<b>Subject</b>	<b>Status Update Meeting Notes for Stanton Street Facility RCRA Project, May 16, 2018</b>	
<b>Attendees</b>	Conor Neal/USEPA Dave Franc/USEPA (via phone) Heather Ziegelbauer/Jacobs Dave Finney/Jacobs Bill Andrae/Jacobs Bruce Manning/Jacobs (via phone) Dave Mitchell/Jacobs (via phone)	Angela Carey/WDNR Judy Fassbender/WDNR Jeff Danko/Tyco-JCI Ryan Suennen/Tyco-JCI Rich Mator/Tyco-JCI (via phone) Joe Janeczek/Tyco-JCI (via phone)
<b>Meeting Date</b>	May 16, 2018	
<b>Location</b>	Milwaukee, Wisconsin

## Status Update Meeting Notes

**Tyco Fire Products LP – Marinette, WI**

*Project Status Meeting*

## 2018 Aggressive Pump Down Operations

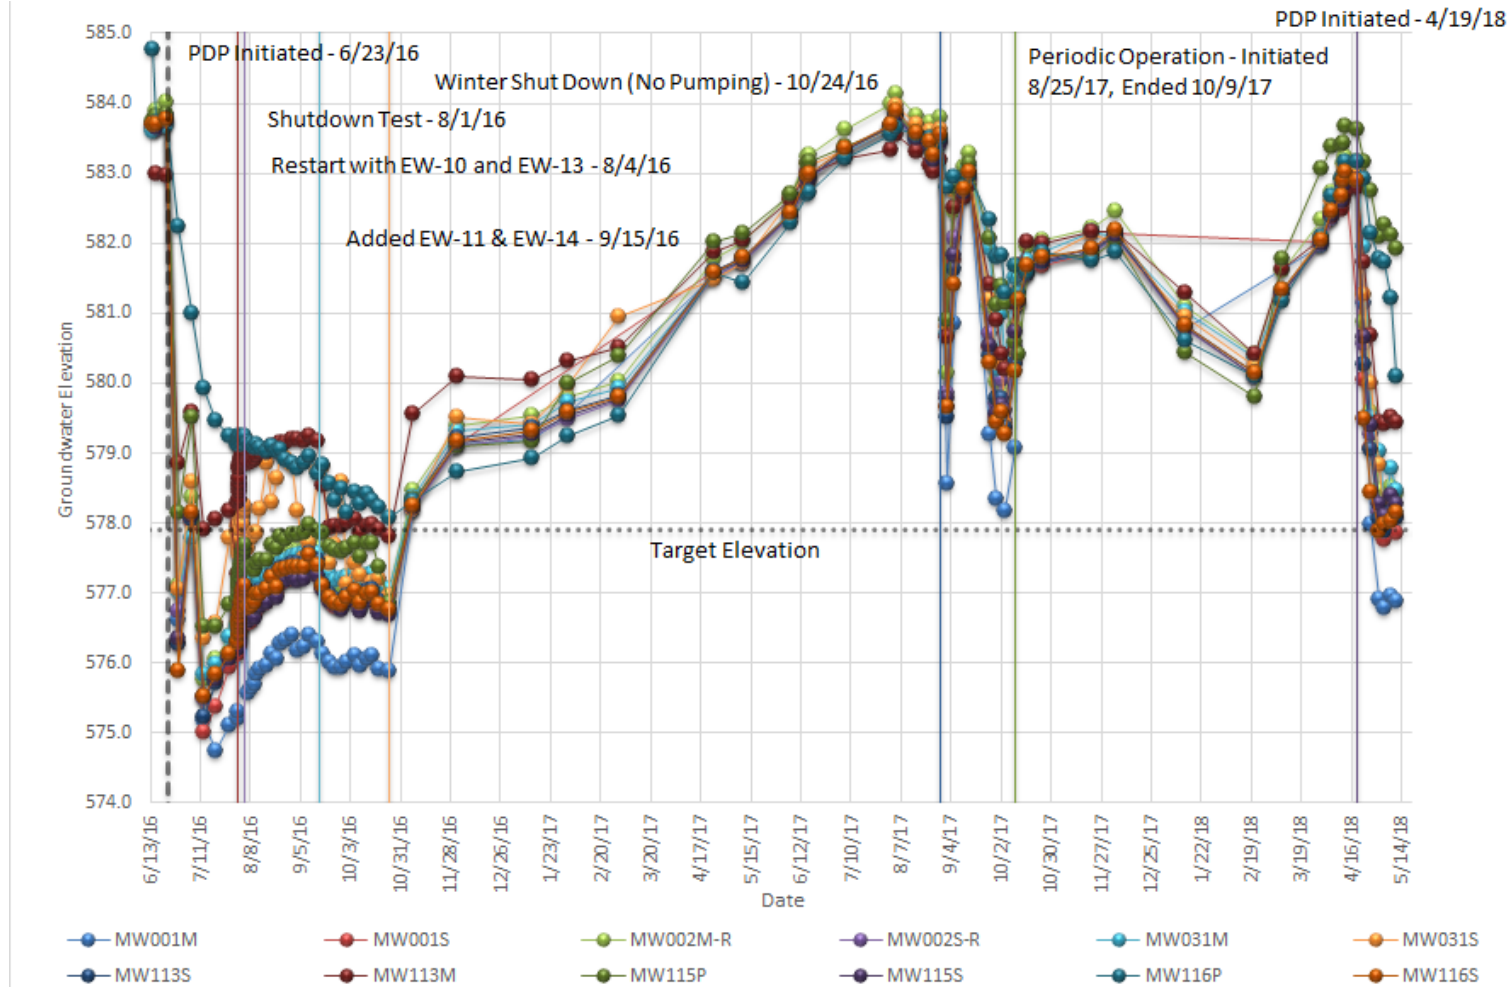
USEPA asked if achieving target groundwater elevations by May 31 is likely.

Tyco is more confident on the former Salt Vault (SV) but not as sure about the former 8<sup>th</sup> Street Slip (8SS); however, are making progress and groundwater elevations are below the river level in both cells. Will continue to pump and maintain progress.

## Pilot DGT Work Plan- General Comment on Deployment Coverage

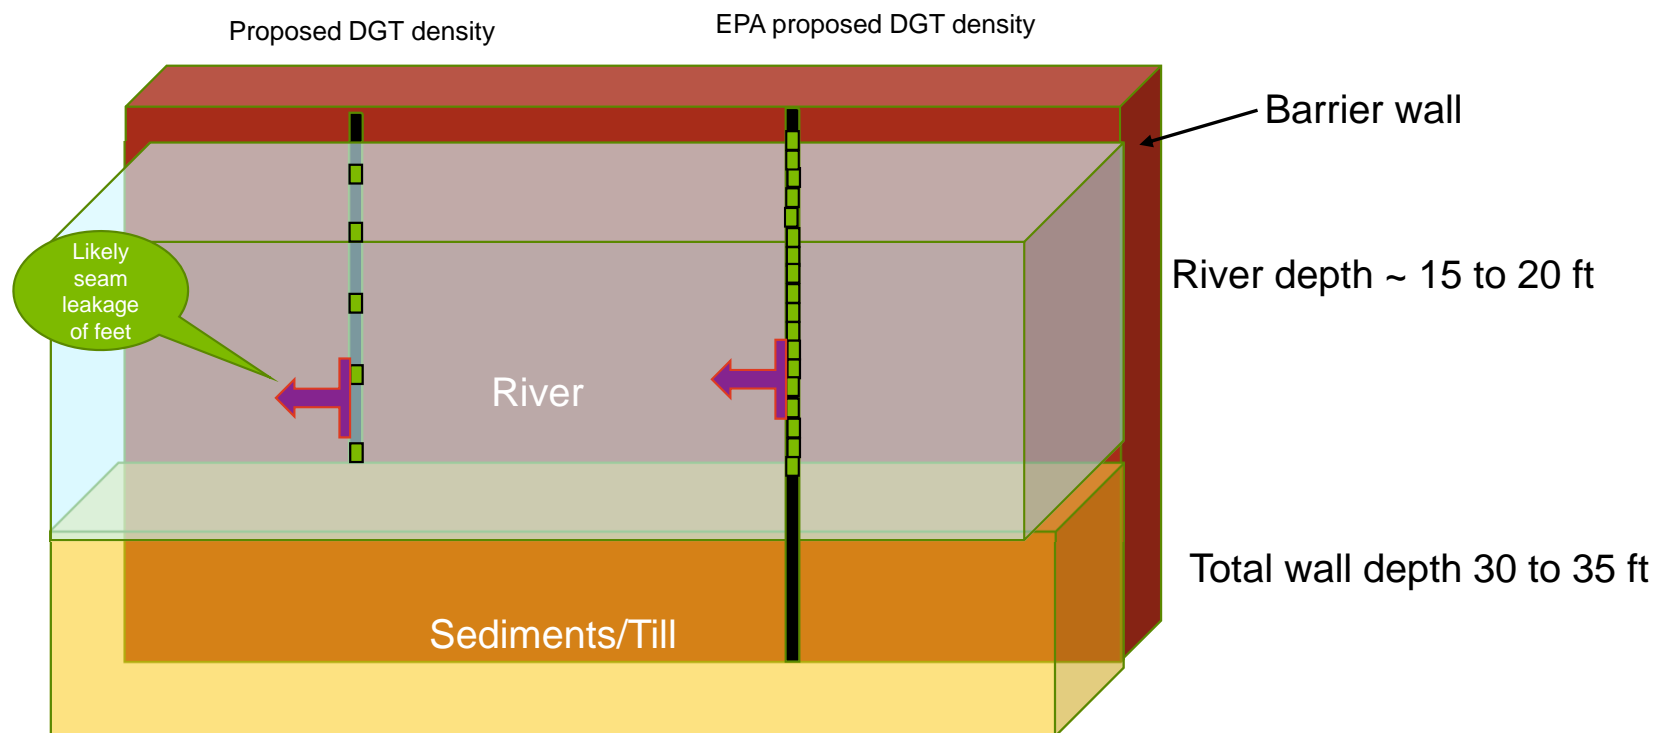
USEPA commented that the RTCs provided a deeper dive into the potential leakage from the wall than provided in the Draft Work Plan. USEPA indicated that the requirement to monitor 15% of wall was not an arbitrary number, but on the lower end of the coverage range that was indicated would occur with the proposed dye testing.

### Increase DGT coverage to 15% of total seam length

- Only 15 to 20 ft of VBW is adjacent to river (rest is in subsurface)
  - Seams below river bottom tested by DGTs in river bottom
- Proposed coverage by EPA would represent 3,465 DGTs if have to consider seams under river bottom

- 1,980 DGTs if consider only seams exposed to river
- Significant deployment and retrieval times (20 weeks total); would not be able to complete in 2018

- Significant cost, given other VBW monitoring occurring
- Not necessary to deploy DGTs along the full exposed seam
  - Seam failure likely to be result of repeated driving of sheet piling causing loss of Adeka sealant

- This mechanism would affect on the order feet of the seam, rather than cause a pinhole leak
- 2014 SEDCAM evaluation suggested 0.15 gpm leakage rate required to recontaminate sediments

- If seam totally unsealed, 0.006 gpm flow would occur through that seam
  - 23 seams would need to be completely unsealed to reach 0.15 gpm (6.9% failure rate)

- Test 15% of seams (50 seams)
- Deploy DGTs every 3 feet on each tested seam
- 98% chance that testing 50 seams will detect a “bad seam” if there is a 6.9% failure rate
